Access Compliance Report

Public Rights-of-Way

(Curb Ramps)

Intersection ID: 29424	Main Street: BRADSTREET_COMMONS_WY	Cross Street: BRAWLEY_LN	Location: NW
ADA ID: 00AF5C00CCA4	Ramp Type: Perp	Initial Pass/Fail: Fail	Overall Compliance: No
Codes/Mitigation Info/Possible Solution		Field Measurements/Component Compliance	
Severity Score: 12.5

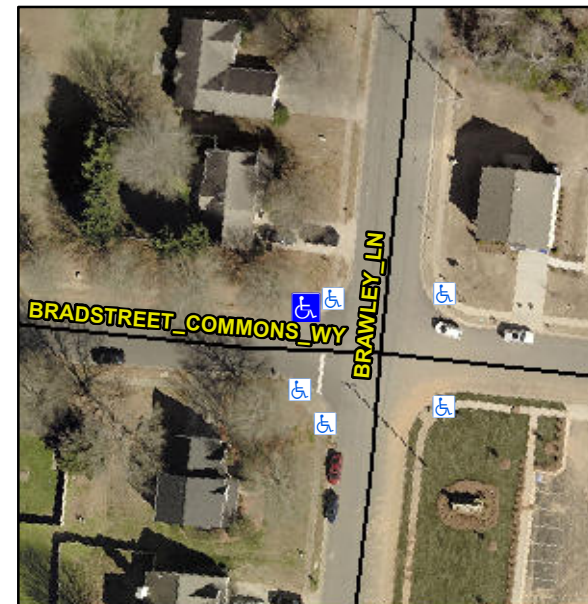
Not Found, R304.2.2

Compliance	Description	Data	Compliance	Description	Data
N/A	Ramp Length (in)	47.5	No	Ramp Slope (%)	9.9
Yes	Ramp Width (in)	48.0	Yes	Ramp XSlope (%)	1.2
N/A	Flare Type LT	N/A	N/A	Flare Type RT	N/A
N/A	Flare Slope LT (%)	N/A	N/A	Flare Slope RT (%)	N/A
N/A	Flare Traversable LT?	N/A	N/A	Flare Traversable RT?	N/A
N/A	Landing Length (in)	N/A	N/A	DWS Provided?	N/A
N/A	Landing Width (in)	N/A	N/A	DWS Contrast?	N/A
N/A	Landing Slope (%)	N/A	N/A	DWS Length (in)	N/A
N/A	Landing X Slope (%)	N/A	N/A	DWS Full Width?	N/A
N/A	Landing Curb? (Y/N)	N/A	N/A	DWS Offset (in)	N/A
N/A	Shared Landing?	N/A			
N/A	Gutter Ponding?	N/A	N/A	Gutter Slope (%)	N/A
N/A	Gutter Lip Ht (in)	N/A	N/A	Gutter X Slope (%)	N/A
N/A	Painted X Walk1?	No	N/A	Painted X Walk2?	N/A
	X Walk 1 Direction	To S		X Walk 2 Direction	N/A
N/A	X Walk 1 Width (in)	N/A	N/A	X Walk 2 Width (in)	N/A
	X Walk 1 Slope (%)	0.4		X Walk 2 Slope (%)	N/A
	X Walk 1 X Slope (%)	1.4		X Walk 2 X Slope (%)	N/A

Remove & Replace Entire Ramp.
